UNITED STATES
DEPARTMENT OF THE INTERIOR
BUREAU OF LAND MANAGEMENT

FORM APPROVED
OMB NO. 1004-0135
Expires: July 31, 2010**SUNDRY NOTICES AND REPORTS ON WELLS**
*Do not use this form for proposals to drill or to re-enter an abandoned well. Use form 3160-3 (APD) for such proposals.***SUBMIT IN TRIPLICATE - Other instructions on reverse side.**

1. Type of Well <input type="checkbox"/> Oil Well <input checked="" type="checkbox"/> Gas Well <input type="checkbox"/> Other		5. Lease Serial No. NMNM18038
2. Name of Operator LATIGO PETROLEUM INCORPORATED Contact: DAVID STEWART Email: david_stewart@oxy.com		6. If Indian, Allottee or Tribe Name
3a. Address MIDLAND, TX 79702-7340	3b. Phone No. (include area code) Ph: 432-685-5717 Fx: 432-685-5742	7. If Unit or CA/Agreement, Name and/or No. SCR443
4. Location of Well (Footage, Sec., T., R., M., or Survey Description) Sec 4 T23S R28E SENW		8. Well Name and No. LOVING FED COM 1
		9. API Well No. 30-015-24333-00-S1
		10. Field and Pool, or Exploratory N. LOVING CASS DRAW' WLC (GAS)
		11. County or Parish, and State EDDY COUNTY, NM

Loving Fed Com 1
30-015-24333
Latigo Petroleum Incorporate
July 22, 2014
Conditions of Approval

OXY USA Inc. - Proposed
Loving Federal #1
API No. 30-015-24333

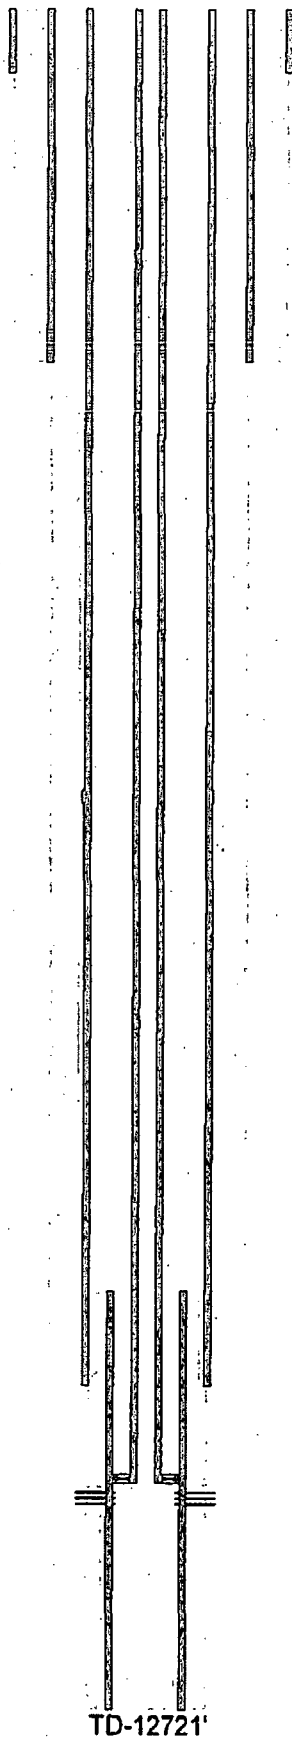
- 1. Step 3: Operator shall set CIBP at 11,408' and place 25 sx Class H Cement on top. WOC and tag. The other two balanced plugs are approved as written.**

CIBP @ 11408' w/ 25sx to 11195'
